### Office Action Summary

10/825,836

HORTON, WADE C.

## DETAILED ACTION

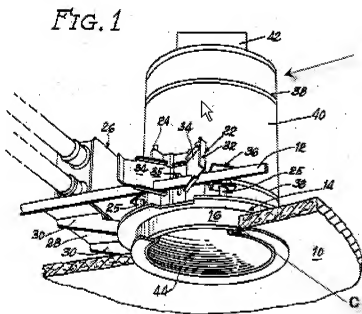
Regarding claim 1, as best understood, Bobrick discloses in combination with a ceiling (10) comprising a planar surface defined by opposing sides and having a circular cutout (c) there through, a recessed lighting fixture (I) mounted on one side of said planar surface over said cutout and conforming thereto, (annotated Fig 1), and a finishing ring (46) defined by an aperture conforming to said cutout, said finishing ring being mounted on another side of said planar surface around said cutout and attached to the recessed lighting fixture (I) for providing a transition from said planar surface to said recessed lighting fixture, (Fig 1, Fig 5), but does not disclose an accent frame comprising a rigid thin sheet of material said rigid thin sheet having an outer edge defining a flat two-dimensional object-shape larger in diameter than a finishing ring, and a convex inner edge defining an circular aperture conforming to said cutout, and having an annular lip circumscribing said aperture and protruding rearwardly there from for insertion into, seating within, and proper positioning with said cutout, said accent frame being sandwiched between said finishing ring and planar surface and maintained in

Regarding claim 9, Bobrick modified by Hill discloses as discussed in claim 1 Bobrick further teaches the planar surface being a ceiling (10), (Fig 1).

FIG. 2.

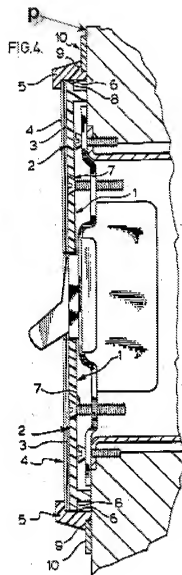
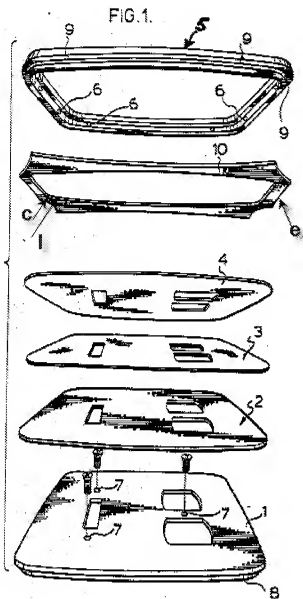
However, Hill teaches an accent frame(10) comprising a rigid thin sheet of material said rigid thin sheet having an outer edge (e) defining a flat two-dimensional object-shape larger in diameter than a finishing ring (5), and a convex inner edge (c) defining an aperture conforming to a cutout, and having an annular lip (l) circumscribing said aperture; said accent frame (10) being sandwiched between said finishing ring (5) and a planar surface and maintained in place there between by the pressure of said finishing ring being retained to the switch plate, (Fig 4); the flat two-dimensional object-shaped outer edge (e) of said accent frame (10) protruding beyond said finishing ring (5) and serves as an aesthetically pleasing backdrop to said finishing ring, serving to cover up any imperfections in the finish or cut of the surrounding planar surface, (Fig 1, 2, 4). Examiner would like to point out that the convex inner edge of Hill is considered to have the same structure of the convex inner edge of the instant application. Therefore, it would have been obvious to a person having ordinary skill in the arts at the time of the applicant's invention to modify the lighting fixture assembly of Bobrick to include an accent frame as taught by Hill in order to provide an ornamental appearance and to enhance the general appearance of the lighting fixture assembly.

The annular protruding lip of Hill does not protrude rearwardly there from for insertion, seating within, and proper positioning with said cutout. However Bobrick teaches that it is well known in the art to have a protruding lip (48) that would allow for easier insertion of the element (46) into the cutout (Fig 2, 5). Therefore, it would have been obvious to a person having ordinary skill in the arts at the time of the applicant's invention to modify the rigid thin sheet of material of Hill to include a protruding lip as taught by Bobrick in order to allow for easier insertion of the element into the cutout.

Regarding claim 2, Bobrick modified by Hill discloses as discussed above. Hill further teaches the accent frame (10) having a decorative outer edge (e), (annotated Fig 1, 2).

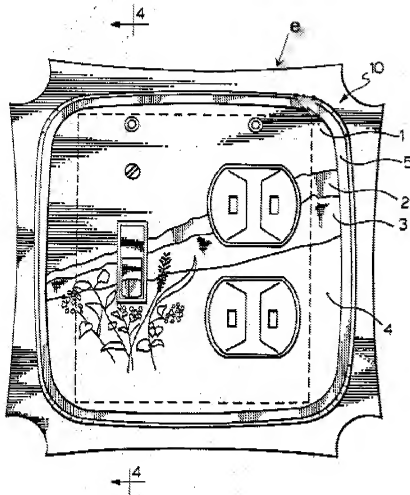
Regarding claim 3, Bobrick modified by Hill discloses as discussed above. Hill further teaches the accent frame (10) being seated flush with said planar surface (p), (annotated Fig 4).

Regarding claim 4, Bobrick modified by Hill discloses as discussed above. Hill further teaches the accent frame (10) flares slightly away from the planar surface (p) to provide an aesthetically pleasing depth or texture to the frame, (annotated Fig 4).
